March 17, 2025

Re: TCCS Solar Carports Project – Tree Study - 101 S. Mills Avenue, Claremont, CA

Exhibit A - TreeWorks® Aerial with Tree Study Points for the Solar Carports Project Area – TCSC – 101 S. Mills Avenue, Claremont
Carlberg Associates

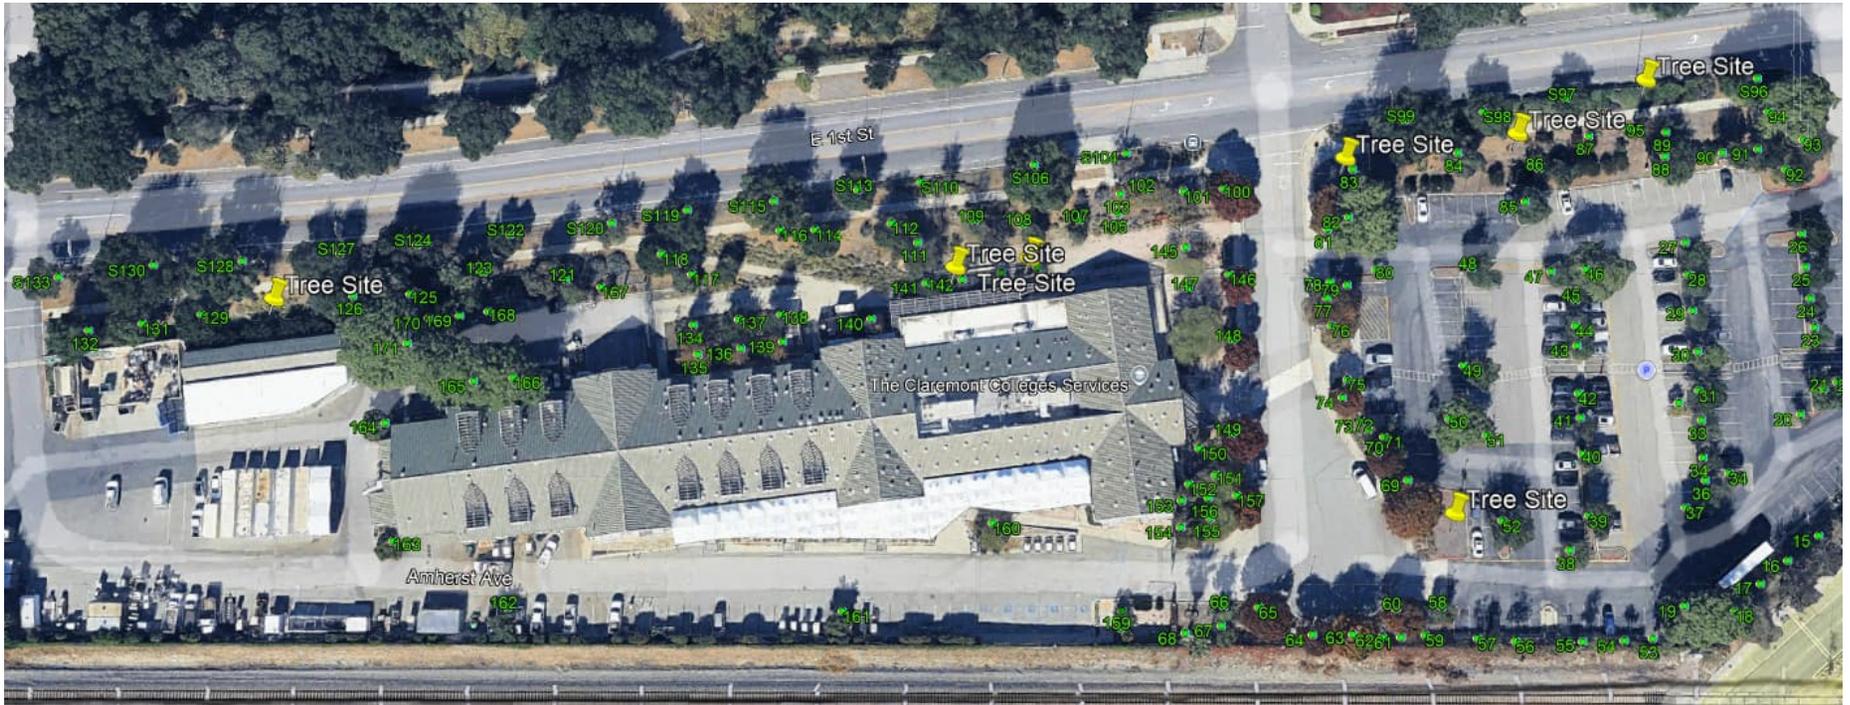
- The majority of the trees in the direct impact areas are in good to very good condition for their age class.
- The spacing of the trees roughly 20-feet apart is a bit close for coast live oaks, but it does not reach the threshold where I would recommend any removals due to overcrowding.
- There will be 32 tree removals due to array placement – these include
 - direct removals due to panel placement
 - they are too close to the panels and will need severe canopy pruning, and/or
 - they will significantly shade the panels when they reach maturity

- There are 24 trees adjacent to the work areas that should be protected during construction to ensure that their root zones and canopies are not significantly impacted by trenching for the new conduit lines or by construction-related equipment.
- There are 115 tree sites that are outside of the direct or immediately adjacent work areas
 - 3 of these sites are now empty

- Tree #S104, outside of the impact area, is recommended for removal and replacement regardless of the project due to a significant decline in health.
- Of the 32 removal trees, Trees #20 and #40 are recommended for removal and replacement regardless of the project due to structural defects.

TreeWorks® Aerial with Potential Tree Replacement Planting Space Points for the Solar Carports Project Area Near the TCCS Administration Office
Carlberg Associates

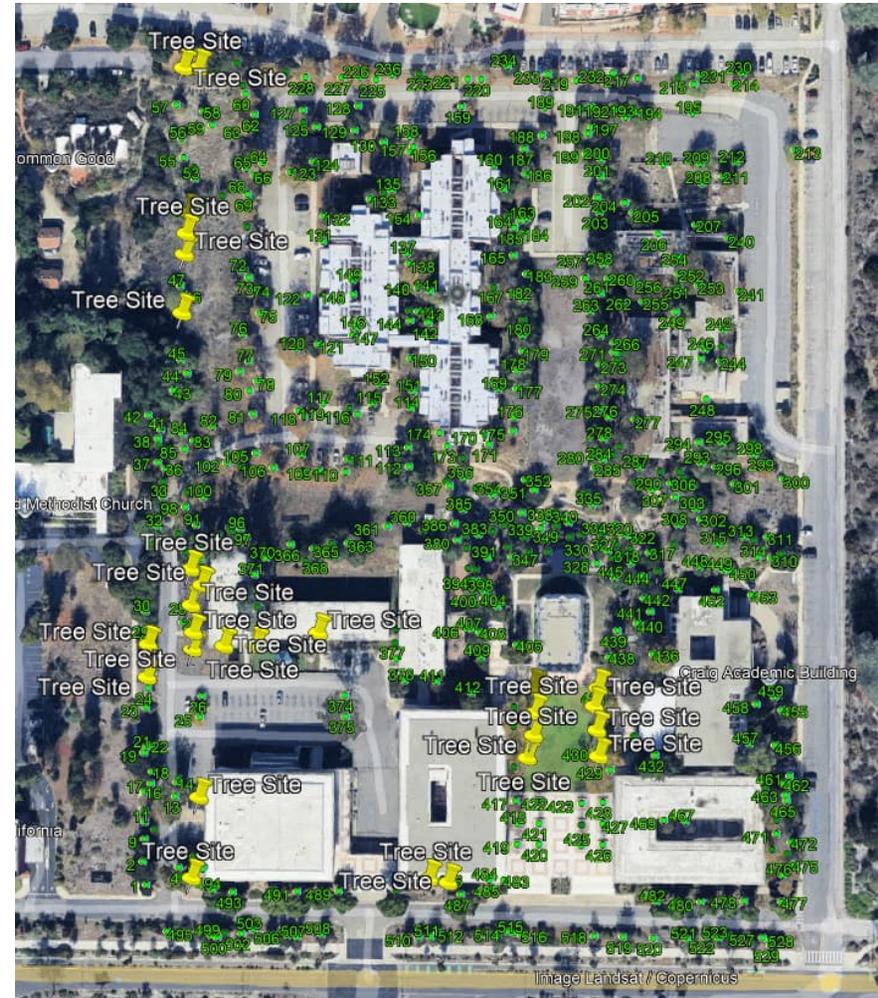
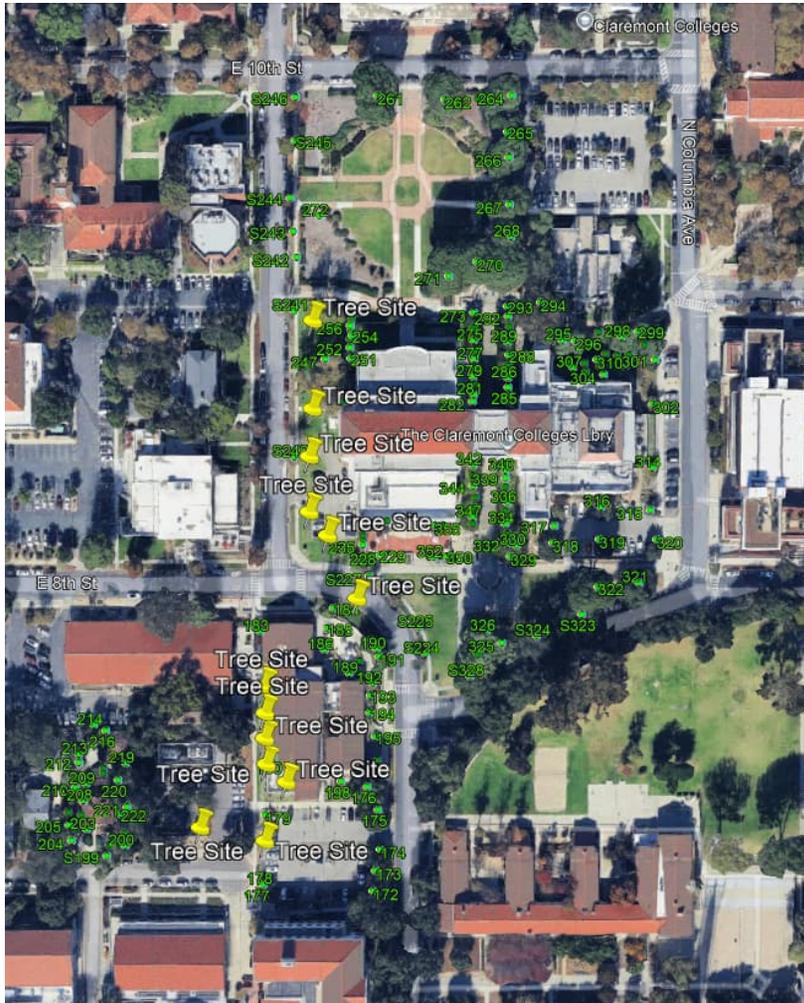
If replacement trees are required, I identified 48 potential planting sites across the TCCS-controlled properties. They include 7 in the landscape areas around the administration building, 13 near the Tarquada Student Services building, and 28 around the southern and western CST/North Campus areas. Photographs of those potential planting sites are attached (taken from our TreeWorks® aerial maps of the TCCS areas). A link to the TreeWorks® .KMZ file will be provided via email. You may use that link to see the points in Google Earth Pro.
